RE: Shure, Inc.

FCC ID: DD4UR1HC

After a review of the submitted information, I have a few comments on the above referenced Application. Depending on your responses, kindly understand there may be additional comments.

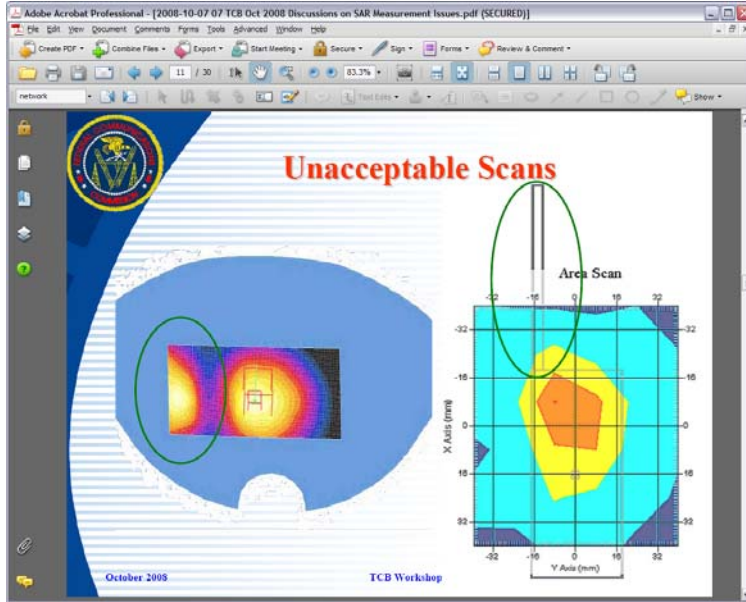
- 6) It was not clear from the photos provided if the microphone was attached during testing despite the text of the document states it was attached the photos do not appear to support this. This is expected to be attached during SAR as it is an accessory that does contain metal and can affect the results. **The accessory was attached for all tests. The microphone was in the Front View picture, but it is located on the other side of the antenna. The small black bump below the antenna is part of the microphone connector.**
